NRC'S HANDOUT

REQUEST FOR ADDITIONAL INFORMATION

TECHNICAL SPECIFICATION AMENDMENT
STEAM GENERATOR TUBE INSPECTIONS WITHIN TUBESHEET
TAC NO. MD0197

WOLF CREEK GENERATING STATION
DOCKET NO. 50-482

Loss Coefficient versus Contact Pressure (Combined Model F and Model D5)

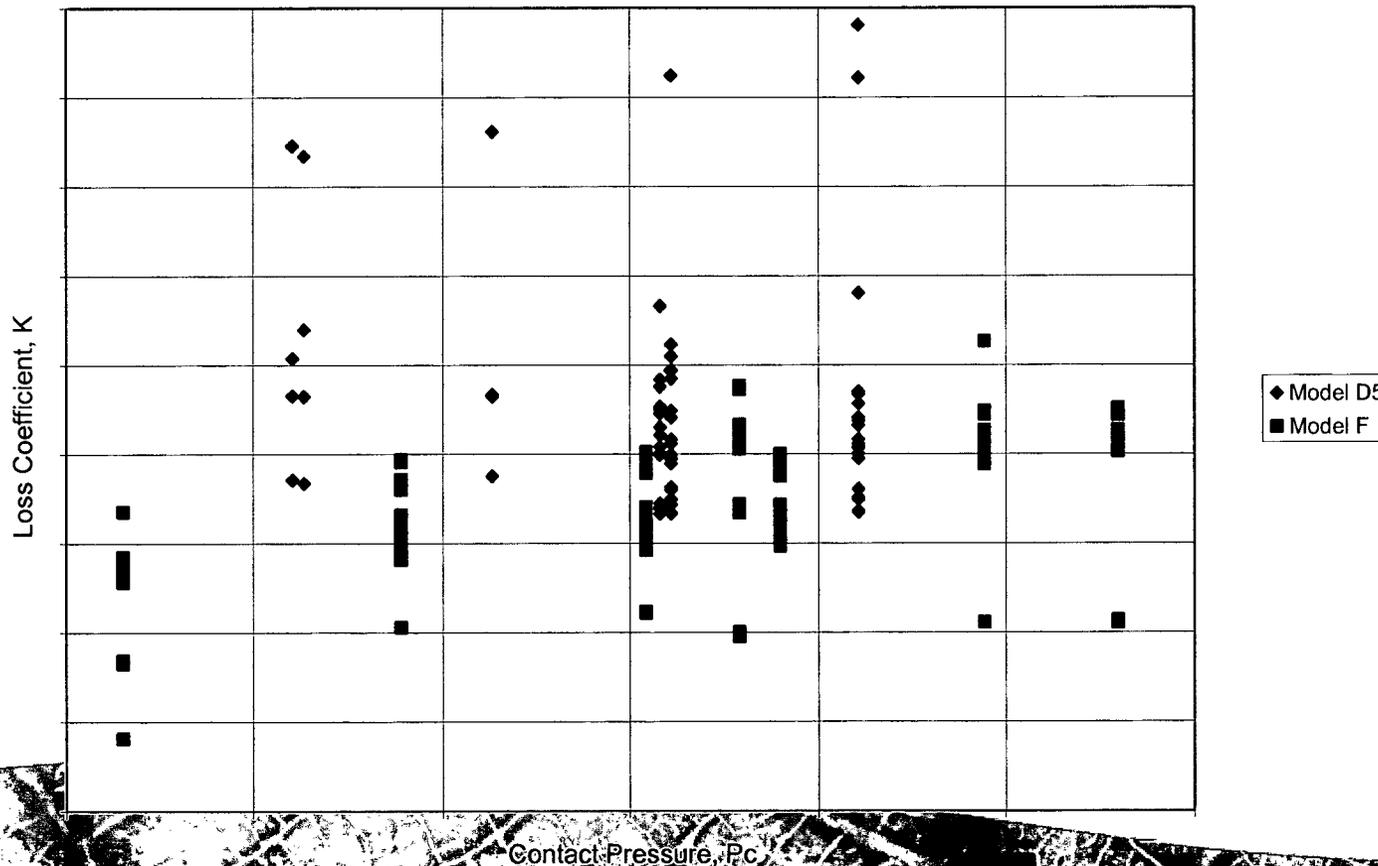
12. Figure 13 of Reference 2, Enclosure I contains additional loss coefficient data from previous leak test results not from the crevice pressure study in the white paper. Provide a figure showing all individual data points from which Figure 13 was developed. Describe the specific applied pressure differentials from the crevice pressure study used to calculate the contact pressure for each data point.

- The data supporting Figure 13 is provided below:

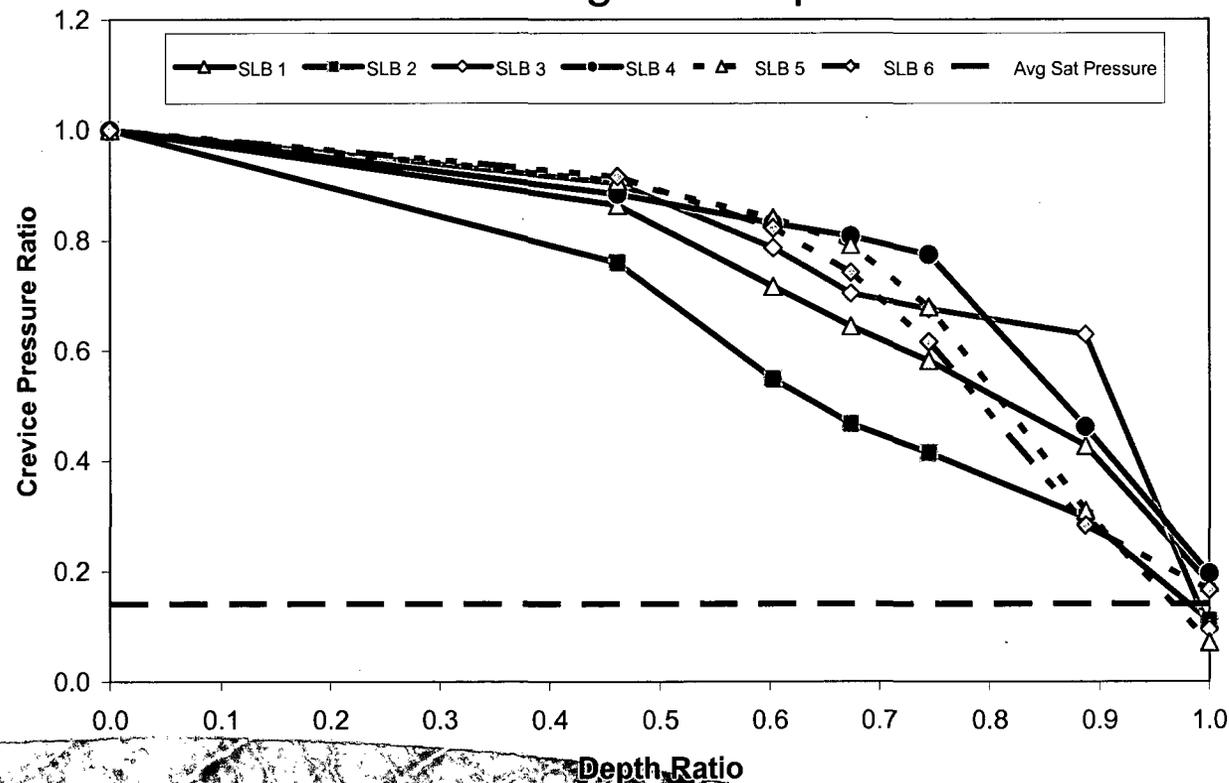
20. Reference 2, Enclosure 1, Attachment 1 - The pressure tap locations in Figure 2 are different from those shown in Figure 3. Discuss and explain this difference or provide corrected figures.

- The ordinate values, the horizontal axis, in Figure 2 of the White Paper are correct. The ordinate values used in the original Figure 3 were incorrect. The revised version of Figure 3 is provided below.

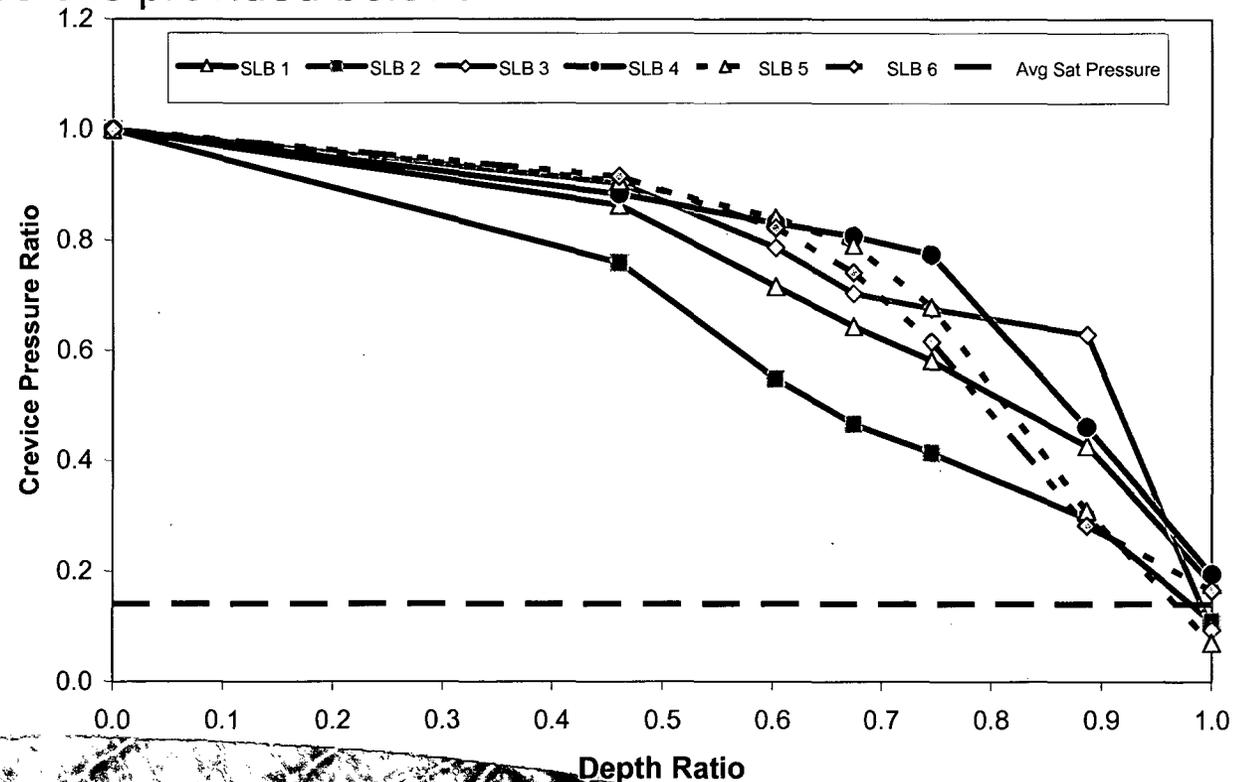
22. Reference 2, Enclosure 1, Attachment 1 - Figure 3 refers to tests labeled SLB 9 and SLB 10 which are not listed in Table 2. Discuss and explain this, or provide a revised Table 2 and Figure 3 showing all test results.

- The White Paper will be revised to correct any typos in the text or figures.
- The data in Table 2 is correct.
- A revised Figure 3 is provided below.
